# SAN FRANCISCO FIRE DEPARTMENT | FIRE STATION 5

CIVIC DESIGN REVIEW PHASE II  
APRIL 20TH, 2015

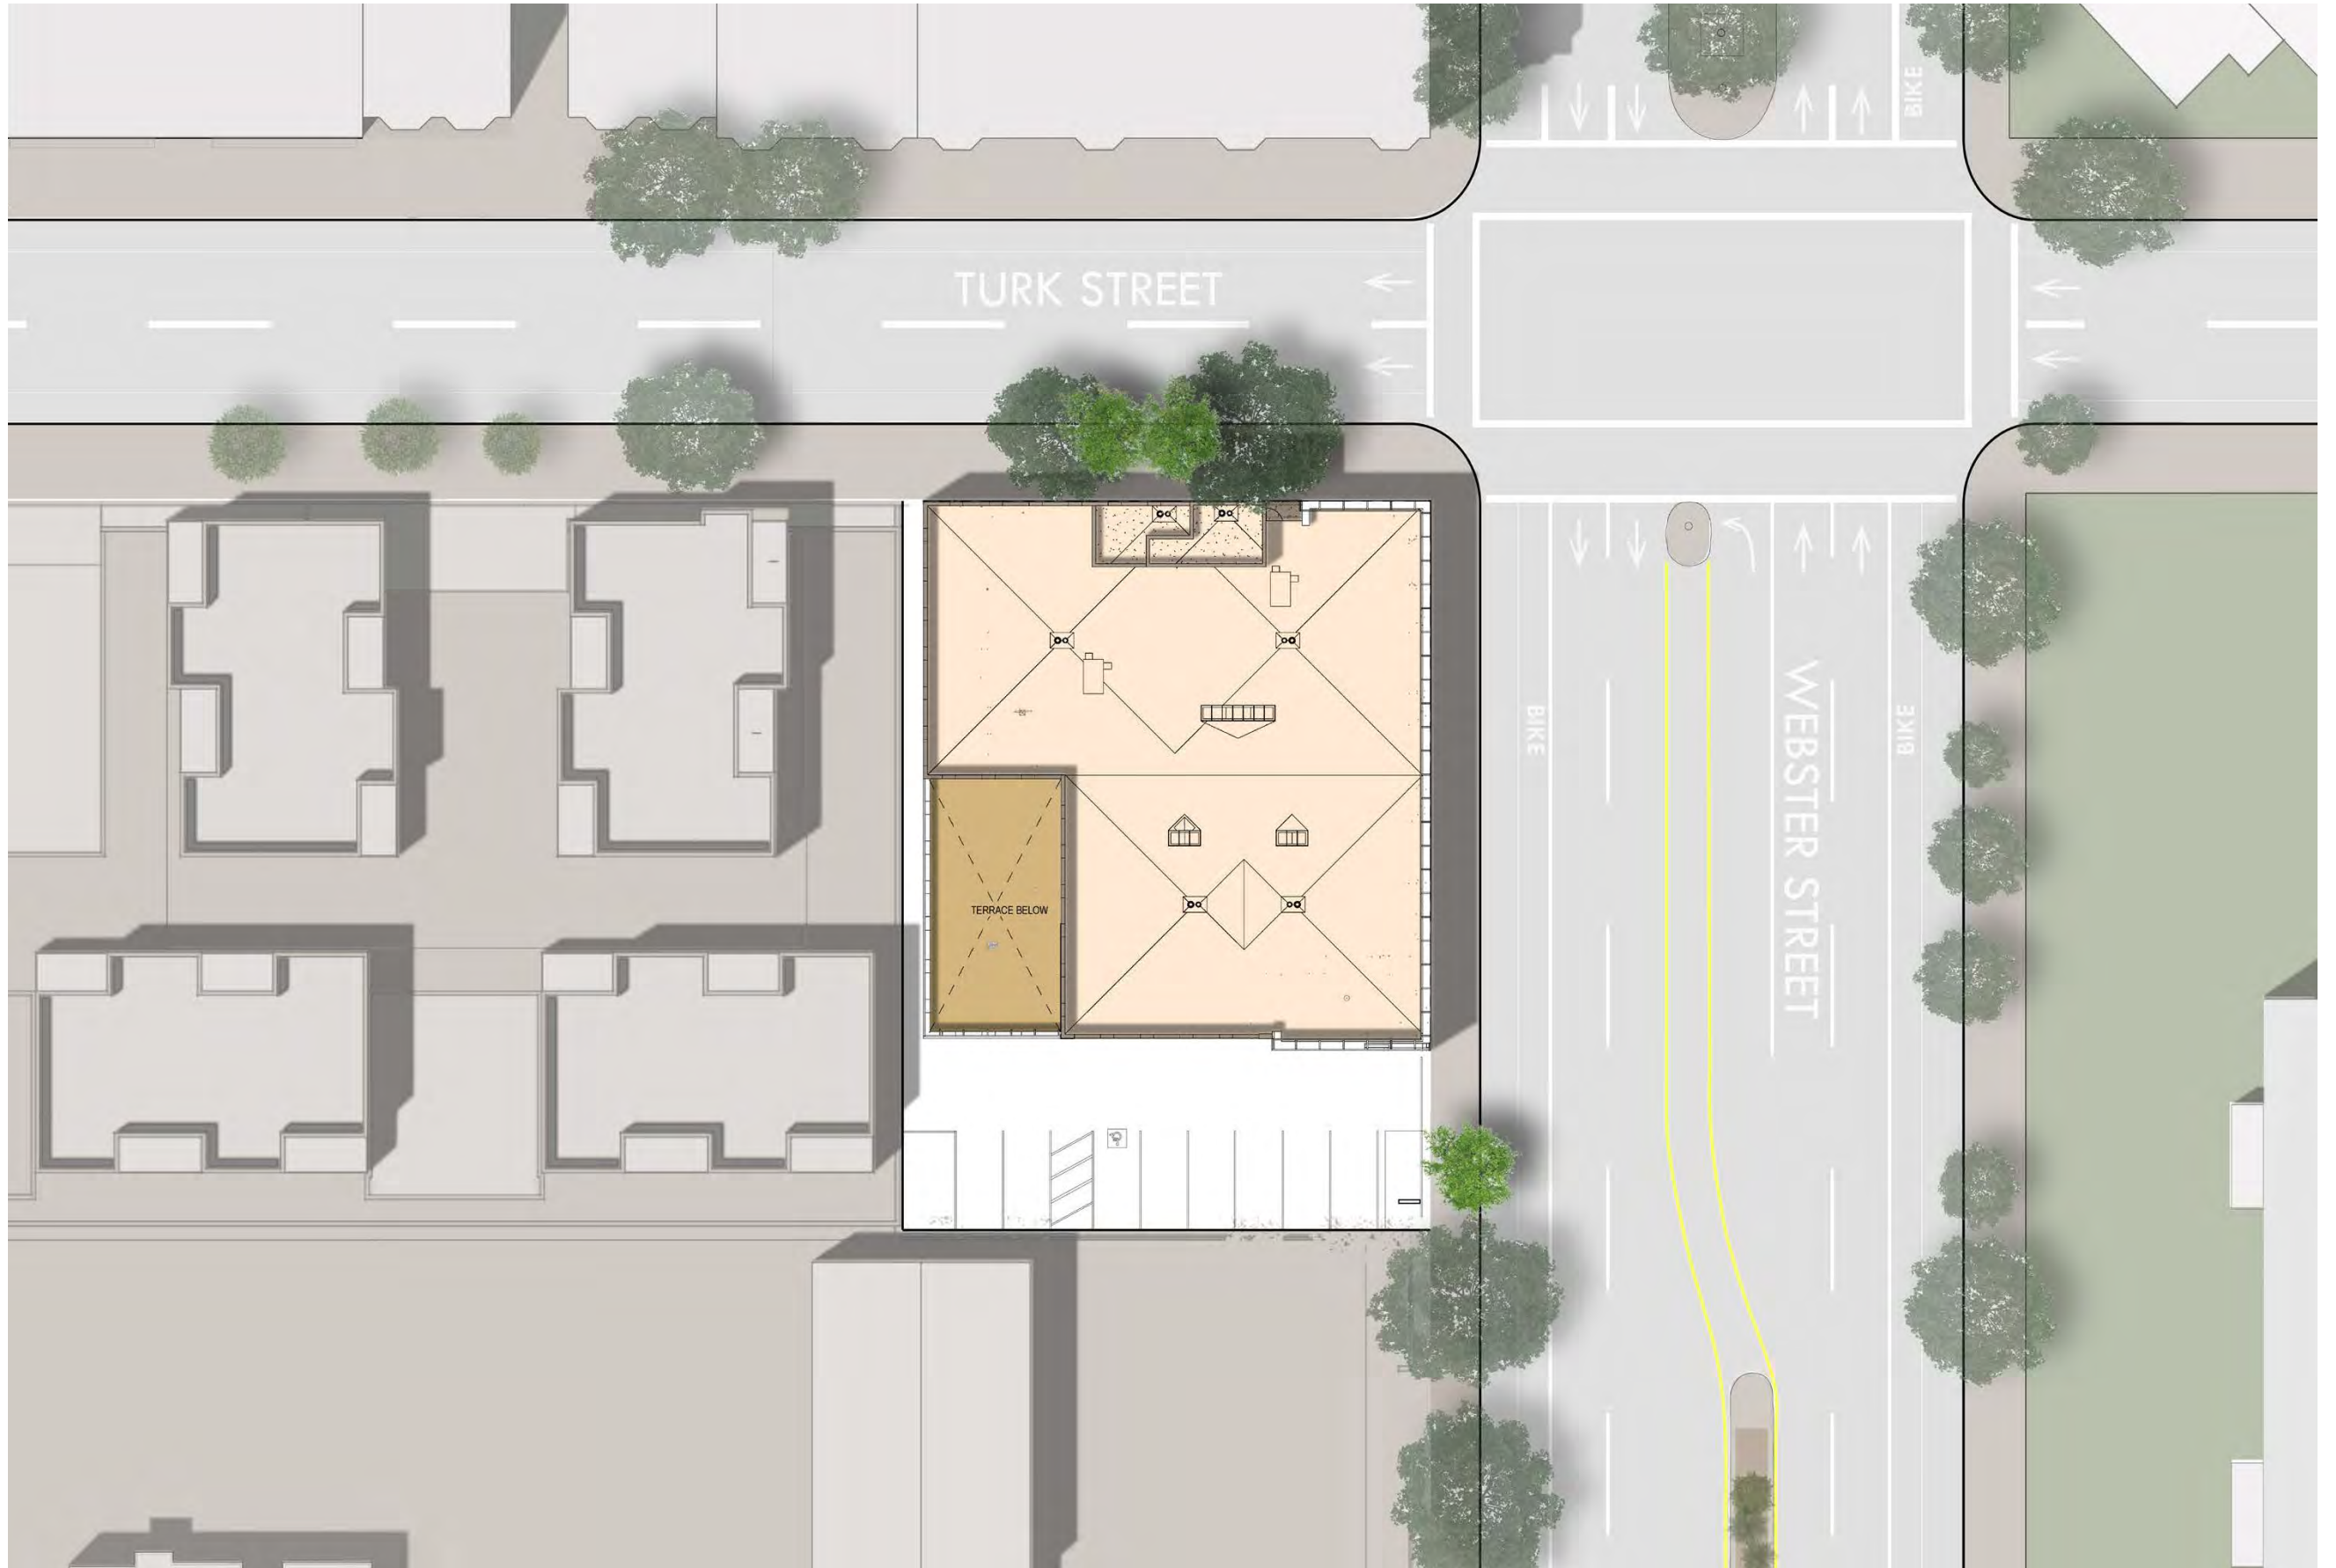
## COMMENTS AFTER PRE-PHASE II INFORMAL

- Carefully study scale of porcelain tile
- Agreed simpler better curtain wall is better choice
- Minimal landscape on this project seems fine
- Preferred tan porcelain tile to grey
- Bring color options to CDR phase II presentation for comment

## CHANGES AFTER PRE-PHASE II INFORMAL

- Changed to curtain wall with horizontal mullions - works better with beds and contrasts vertical metal panels
- Need protective elements for training ladders
- Grey metal panel at rear now acts as terrace parapet
- Simplified color scheme with interlocking materials at mezzanine
- Considering tan tile as alternate to grey
